**State of Rhode Island And Providence Plantations
3/3/11
ADDENDUM NUMBER FOUR**

RFQ # 7448230

**TITLE: ARRA-CHAFEE HALL FIRE PROTECTION UPGRADES -
URI**

DOCUMENT 00900 - ADDENDA AND MODIFICATIONS #4

**FIRST FLOOR
REFLECTED CEILING
PLAN**

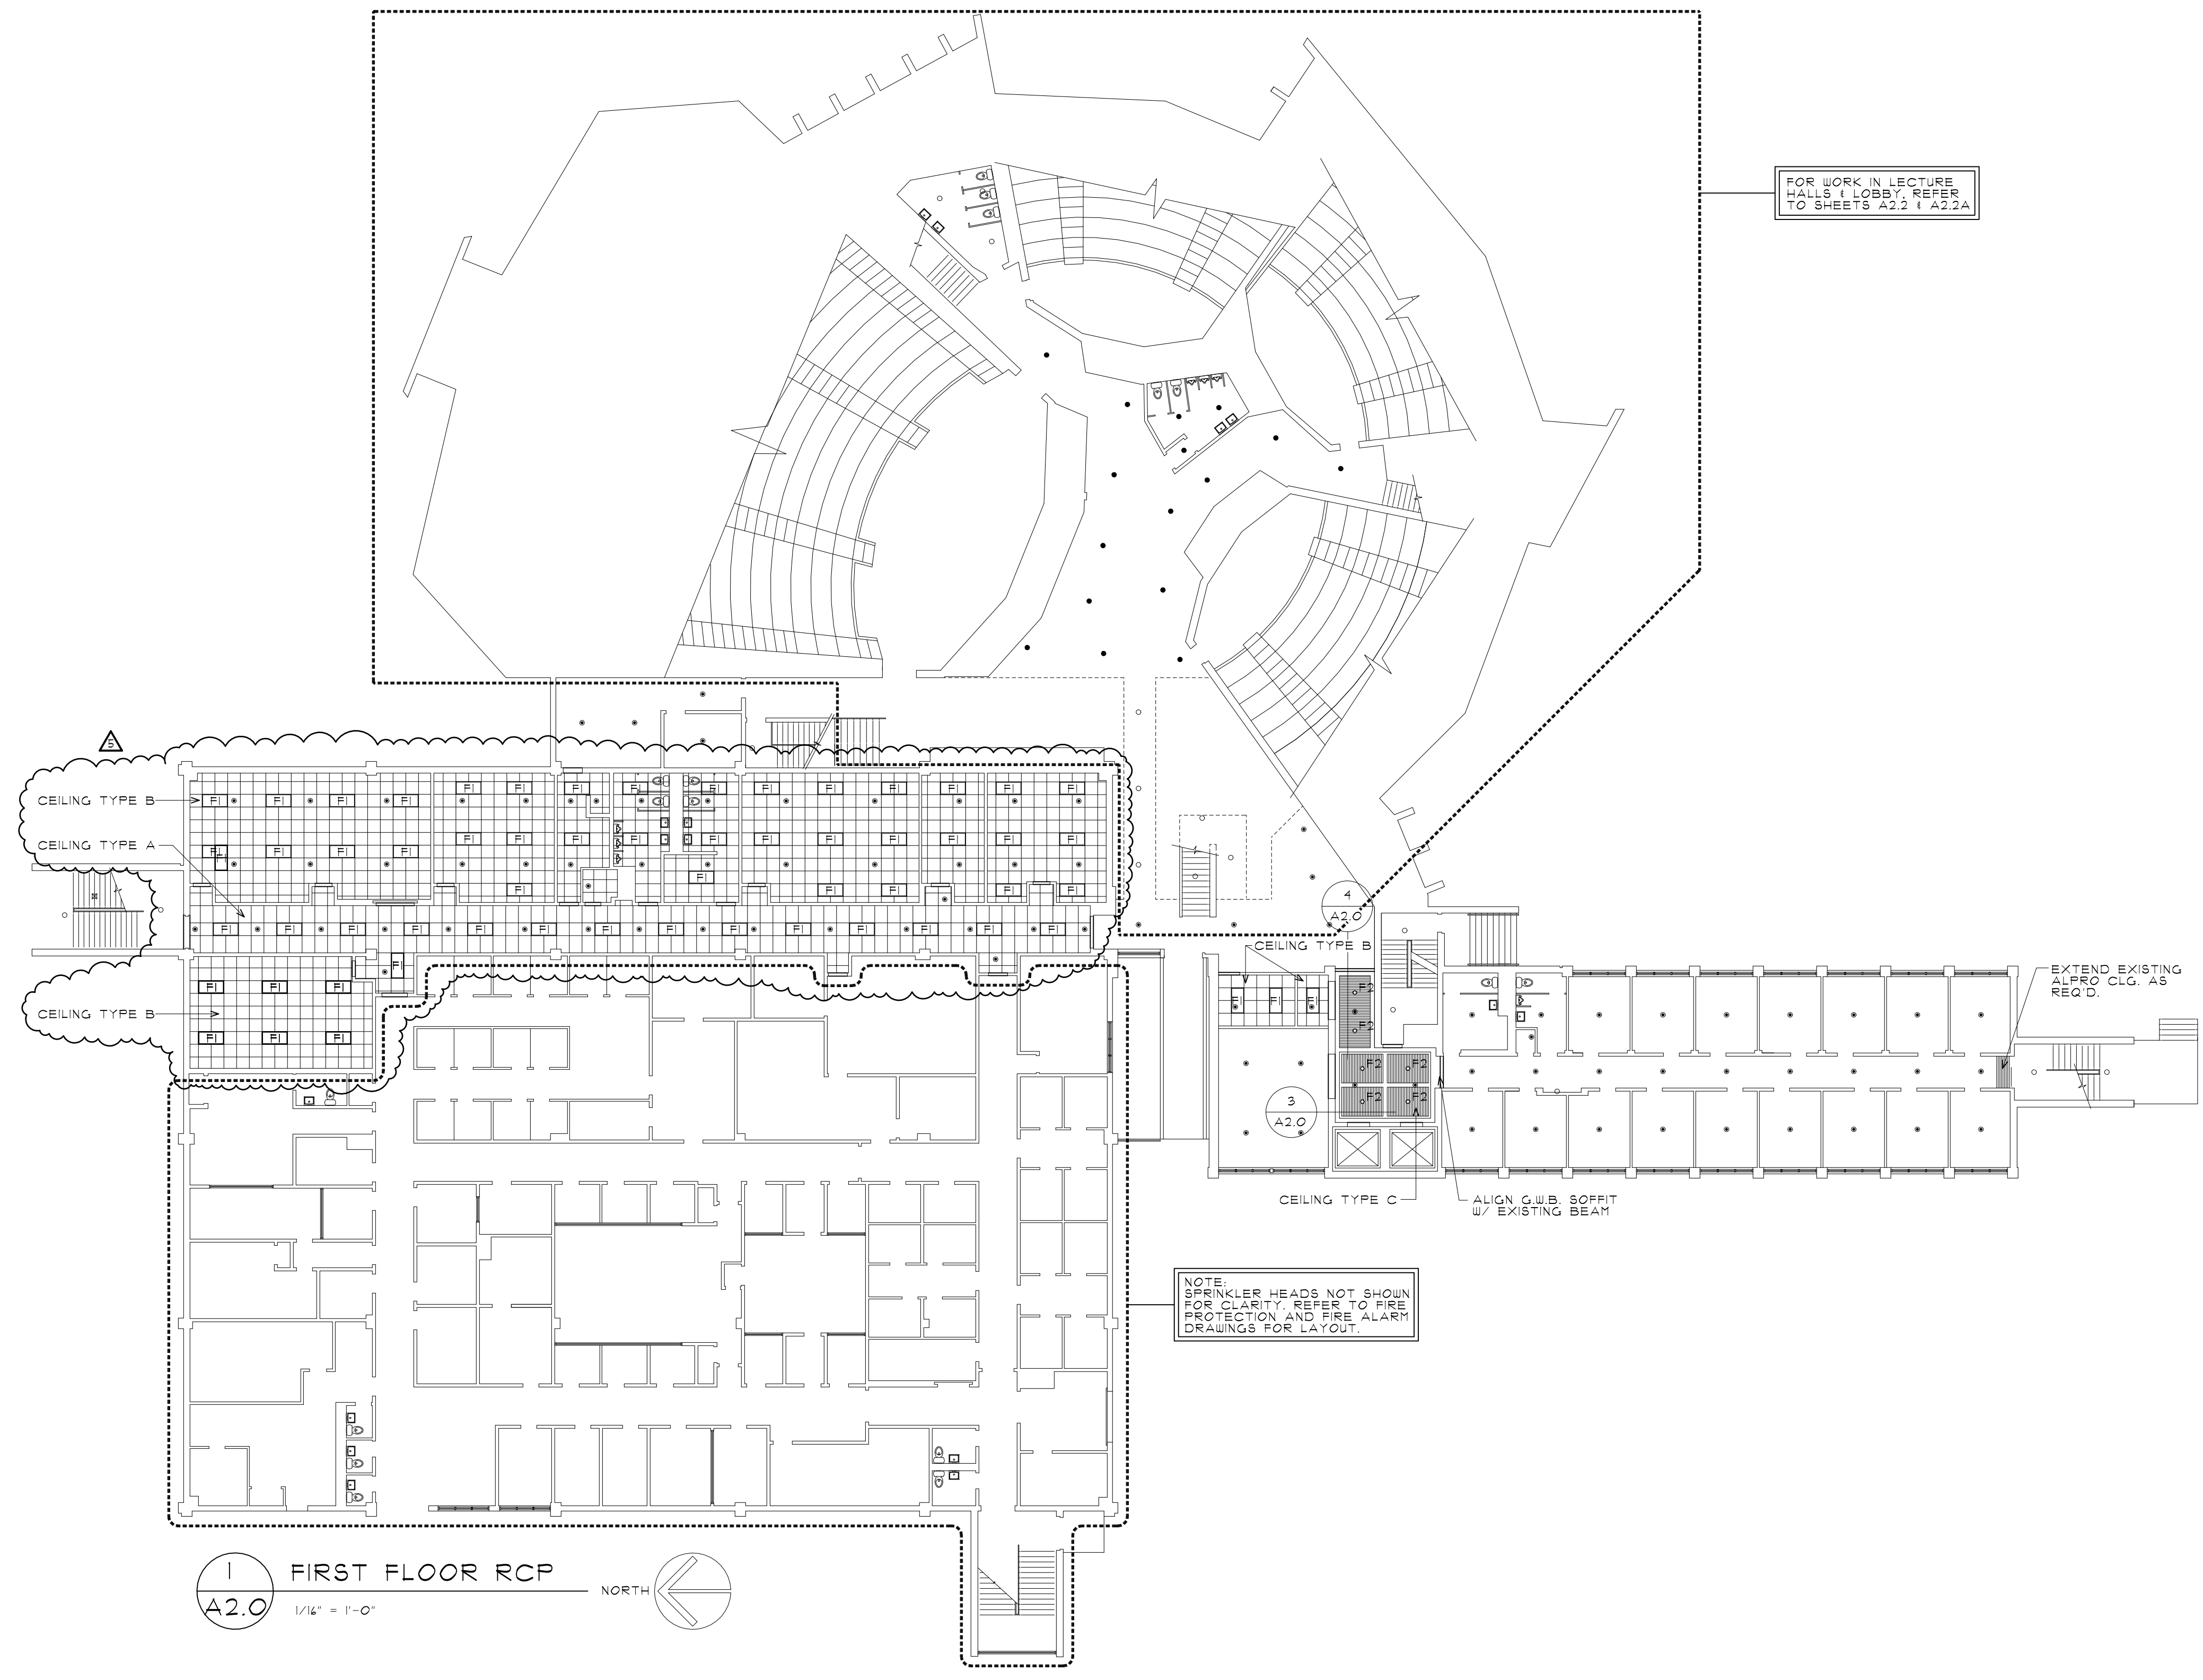
A. Replace Drawings D1.0 and A2.0 with new sheets D1.0 and A2.0 dated 03/01/11 issued as part of this addendum.

DATE: 02/25/11
DRAWN BY: CMM
APPROVED BY: NJG
DESIGNED BY: SMT
SHEET #: SKA - #1

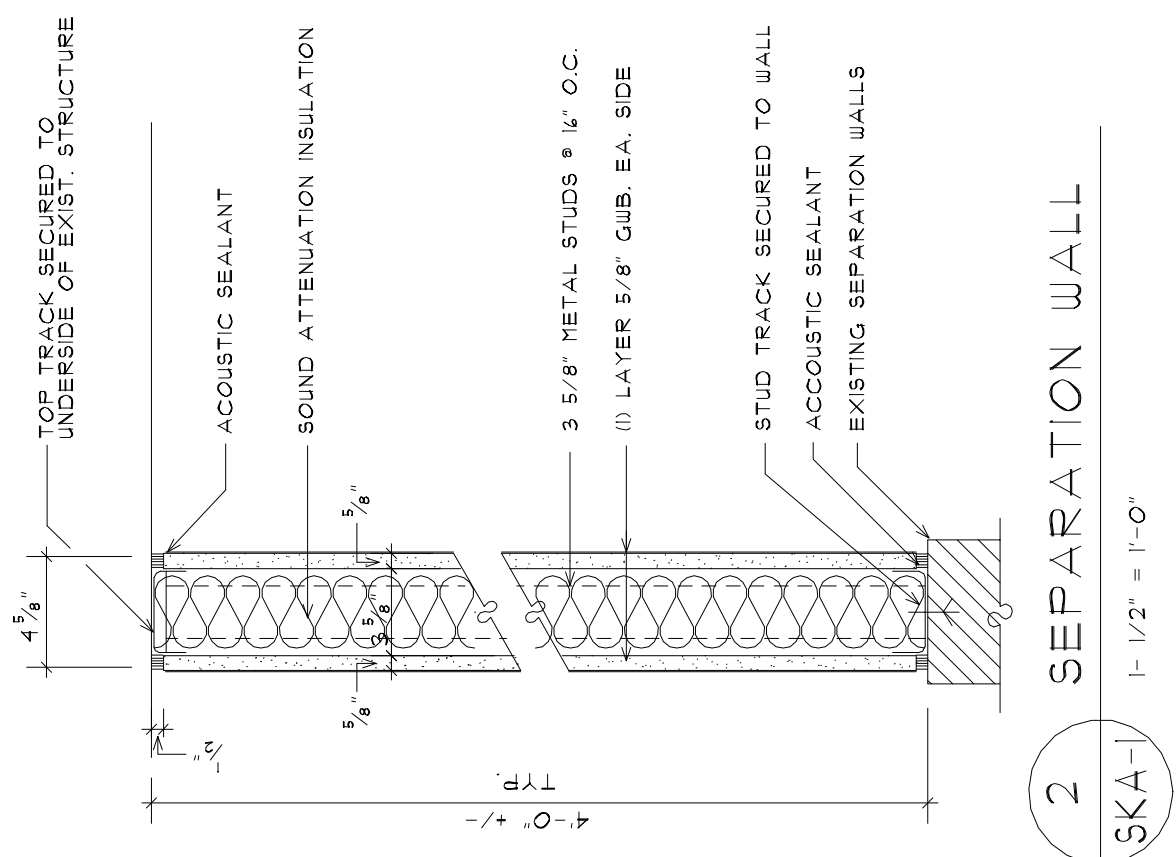
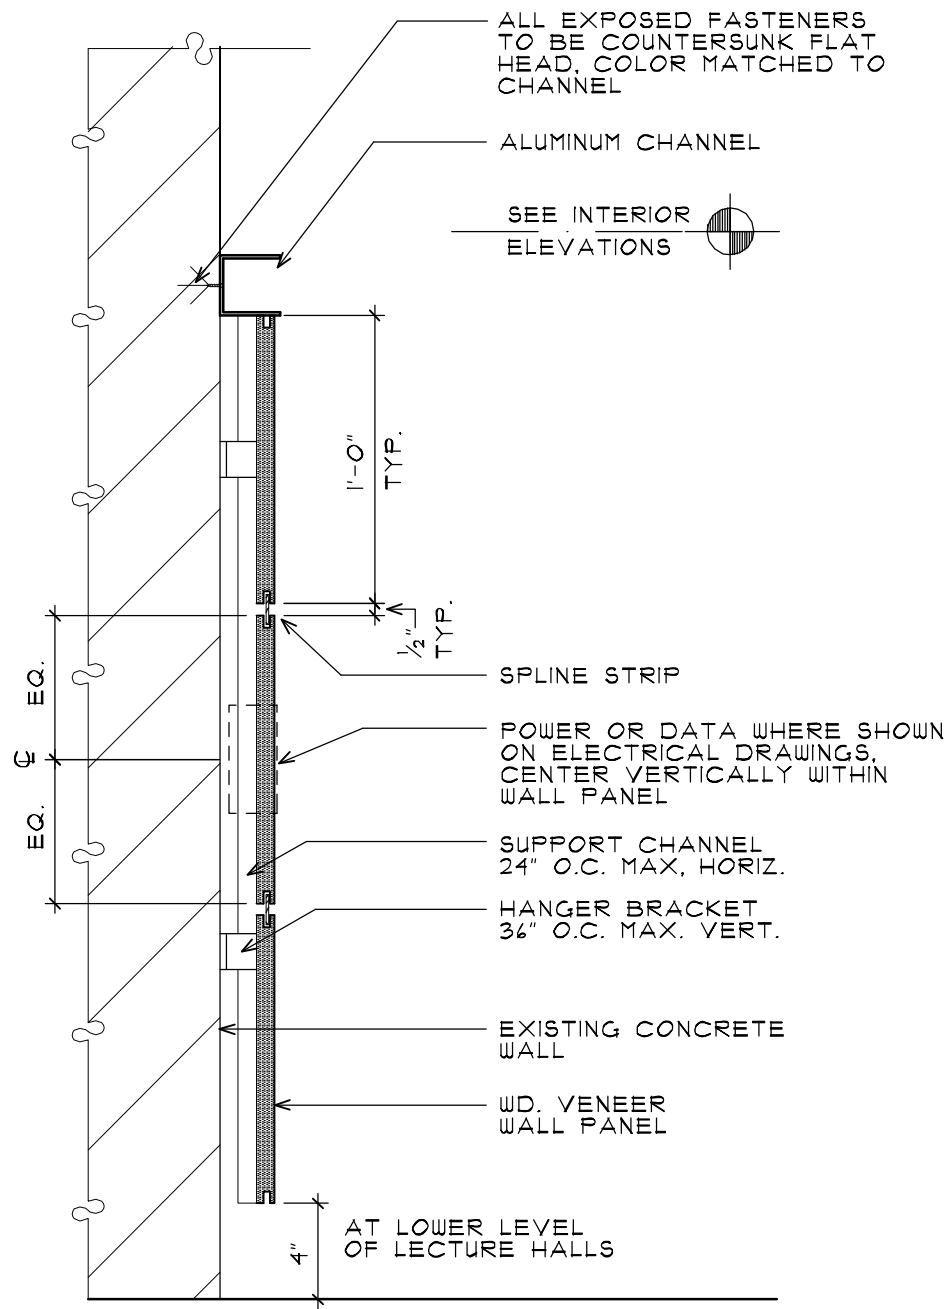
C. Add information regarding the top of wall closure to Drawing A1.1 per the attached sketch SKA-#1 dated 02/25/11. This work is a part of the Base Bid.

APPROX. LINEAR FOOTAGE OF LECTURE HALL SEPARATION WALLS: 85'-0"

UNIVERSITY OF RHODE ISLAND CHAFFEE HALL
FIRE PROTECTION UPGRADES
CHAFFEE HALL
RESPONSE TO SET FINDINGS
REFERENCE DRAWING: A3.1

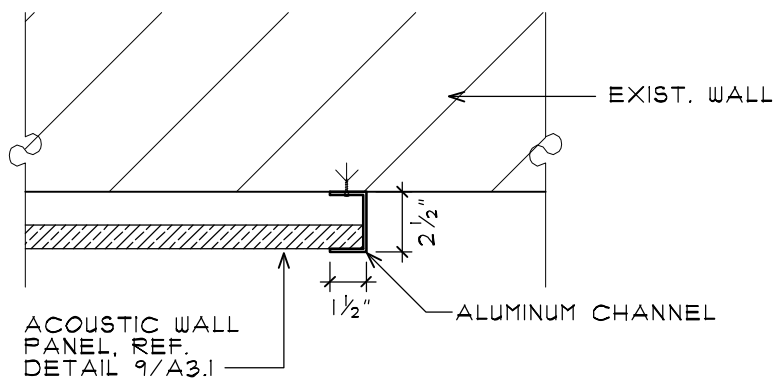
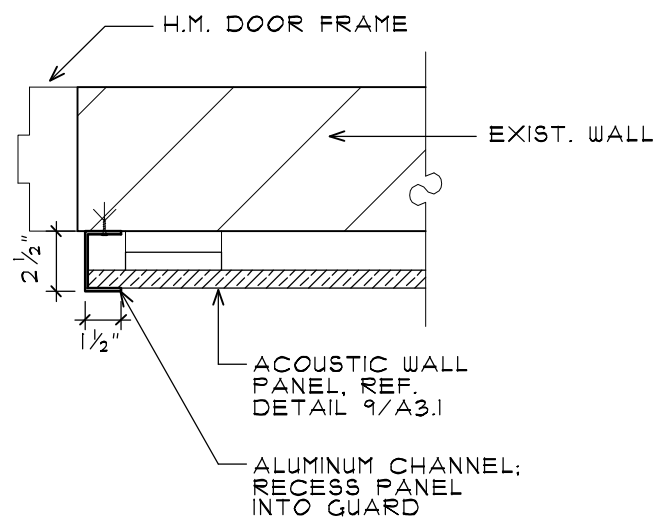
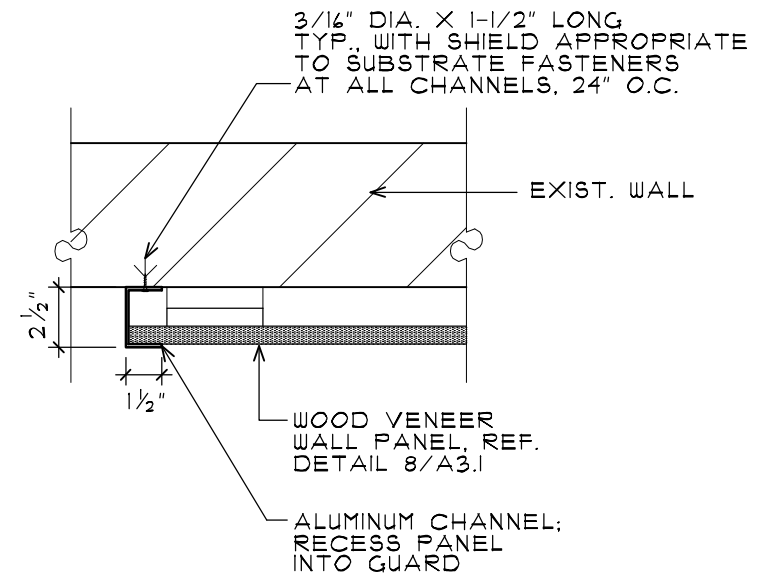
D. Revise details on Drawing A3.1 and A3.1A per the attached sketches SKA-#2 and SKA-#3 dated 02/25/11. These describe changes to the aluminum wall panel trim. This work is part of the Base Bid when described on A3.1, and part of alternate work if found on A3.1A.

Answer: The custom aluminum extrusions shown on the wall section details are hereby revised to standard aluminum “C” channels. Refer to specification and drawing changes issued in this addendum for material, size and application.

“C. Aluminum Channel: Provide aluminum pieces as detailed that are not a standard part of the wall panel assembly by Armstrong. Square-corner C channels shall be by Argyle Industries, Inc. or equal. 160 Meister Ave. Branchburg, NJ 08876, 800-320-6461. www.argylein.com. Refer to details for sizes.”

SECTION C
STAIR IB

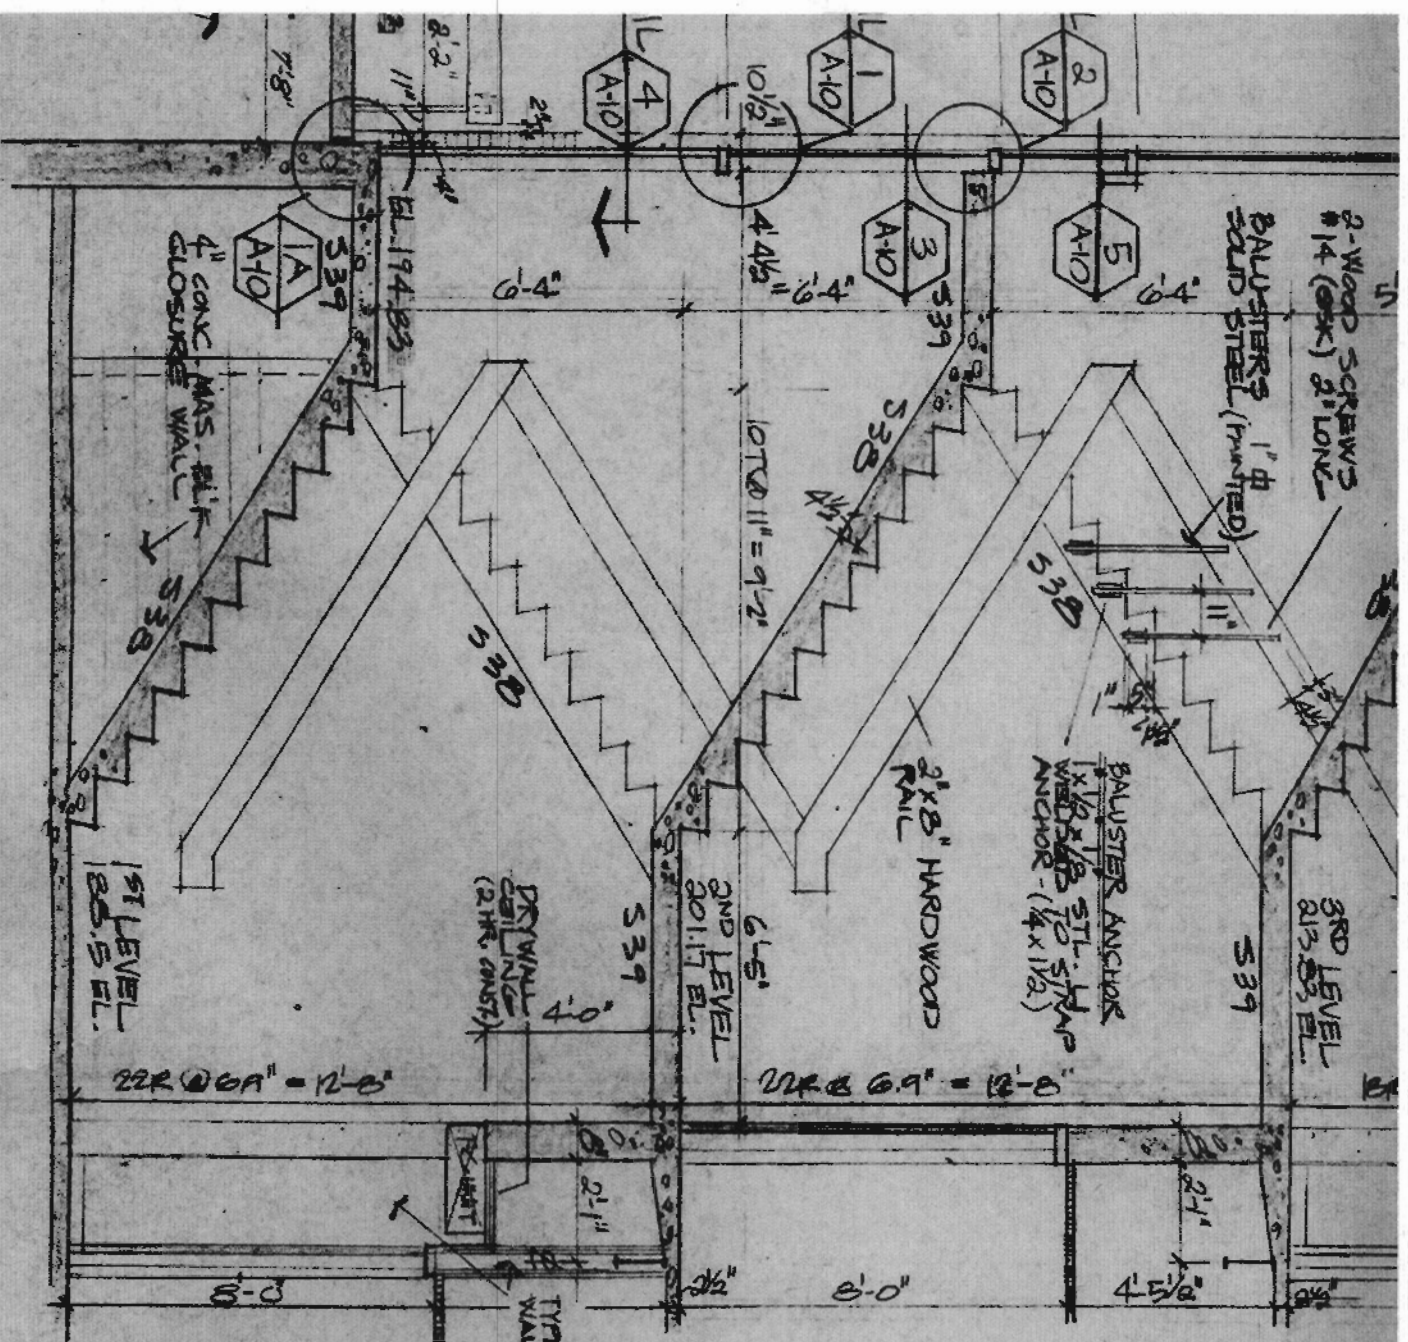
E. Original building construction details are offered in the attached sketch of Section C Stair B to clarify the existing assembly detail of the stair rail posts to be demolished. There are steel strap anchors embedded in the concrete, concealed by parging material, to which the post base is welded. The work includes cutting the post base from the embedded anchor and repairing the parging as necessary to achieve a finished look in conjunction with the new rail system.
